RECEIVED
 JUL 27 2007
 RESUBMIT APPROVED BY X D...
 DATE 07/31/07

HIGHWAY SAFETY CORP.
 GLASTONBURY, CT

TRI-CHORD SIGN STRUCTURE
 STATE OF VERMONT
 COUNTY OF CALEDONIA
 MM 129.130 SB
 PROJECT No. HES 091-3(42)
 HES 093-1(10)

DRAWN: MHM
 CHECKED: P. Radice
 DATE: 5/23/07
 SCALE: NTS
 HSC REFERENCE NO.: 1587d
 SIZE: D REVISION: 0
 SHEET NO.: 3 of 8

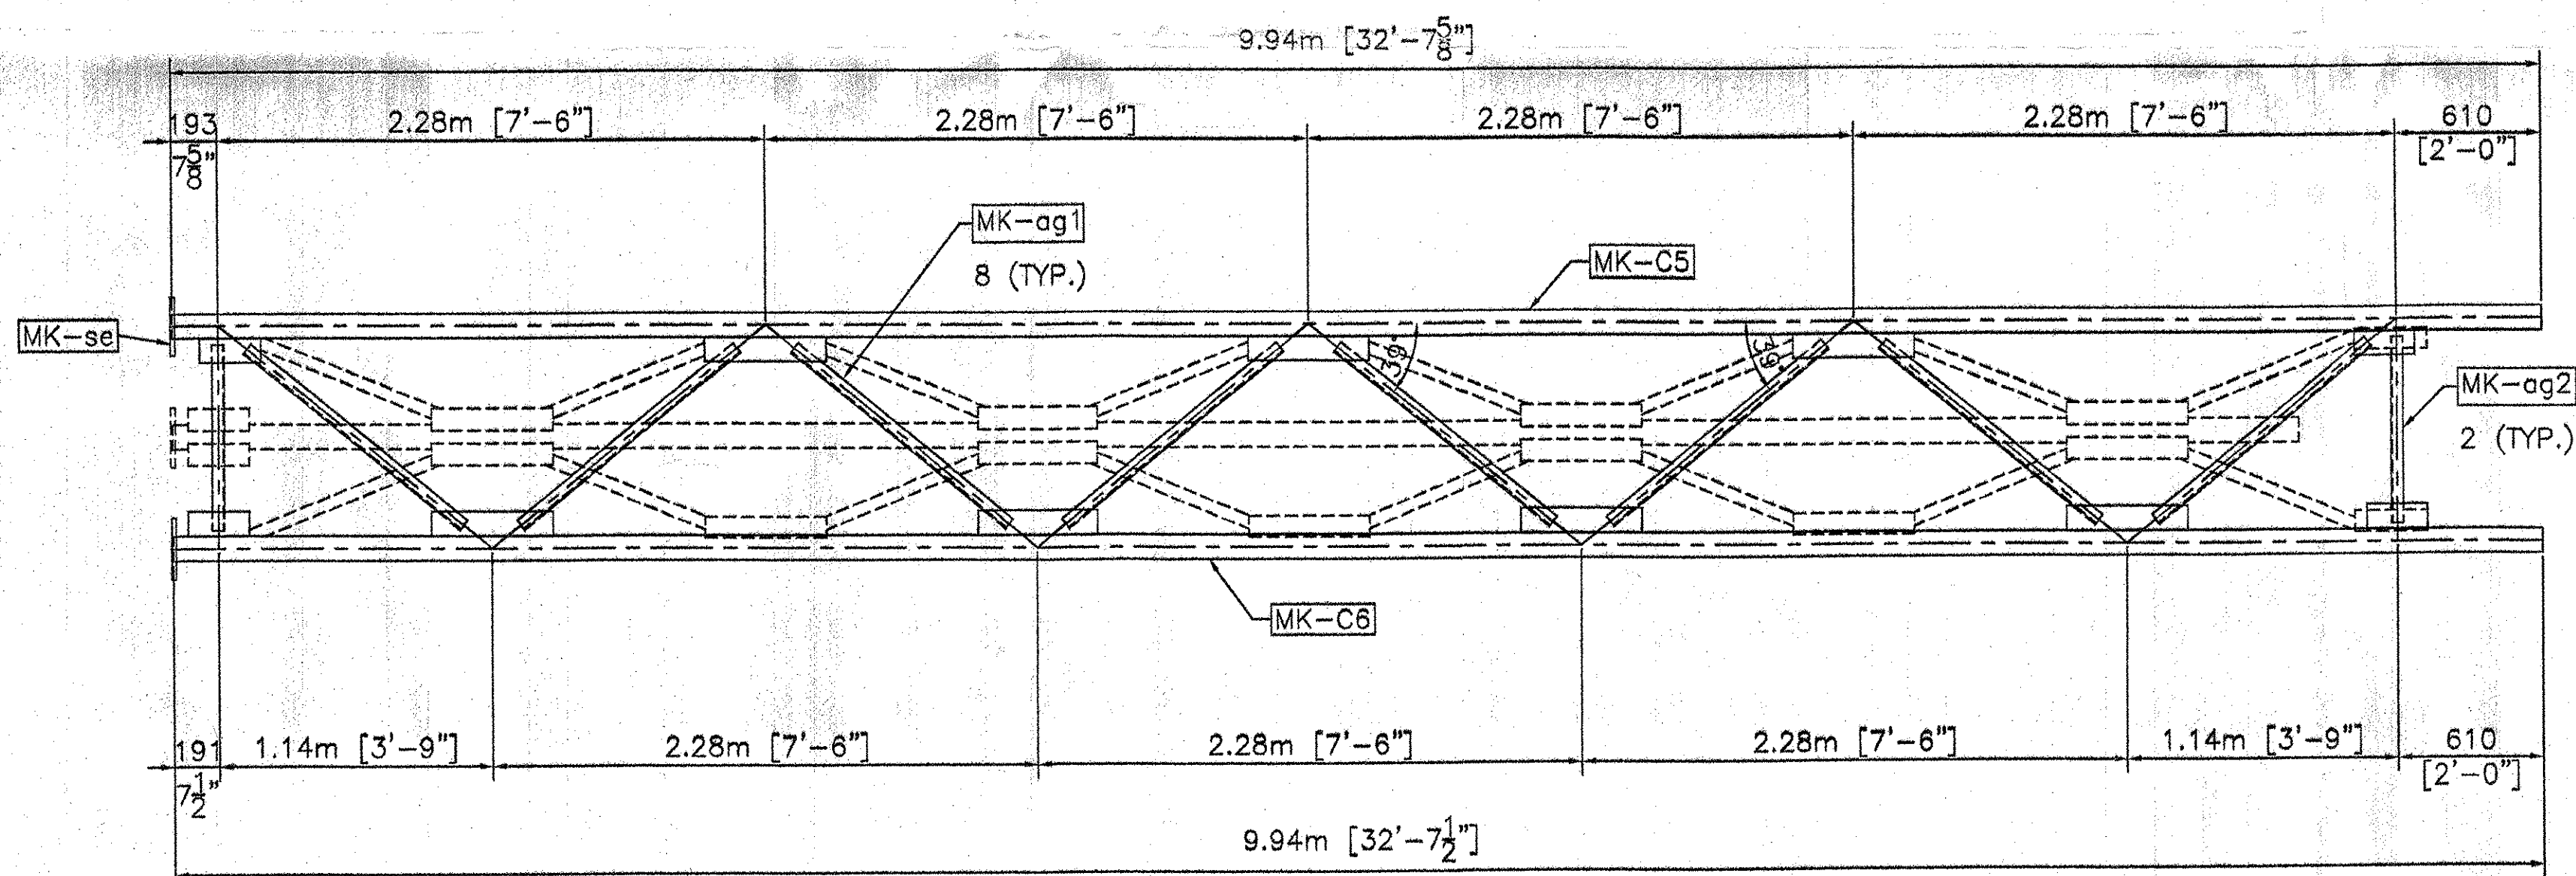
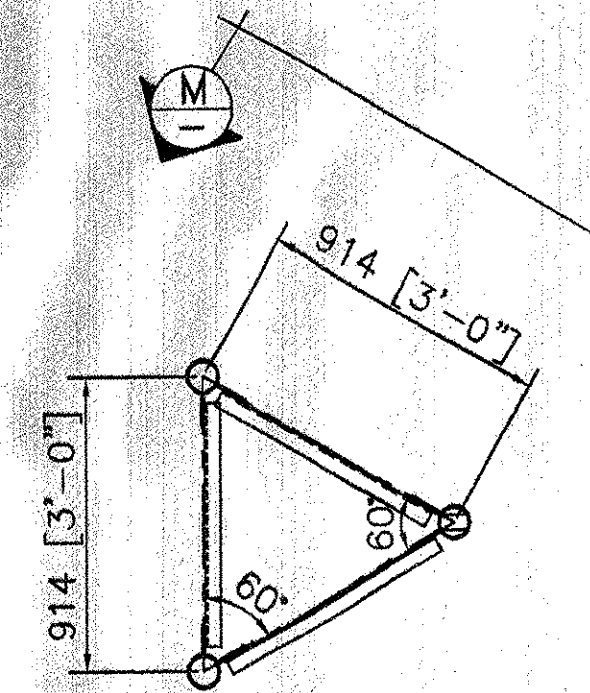
17. See Weld all connections when possible prior to galvanizing.
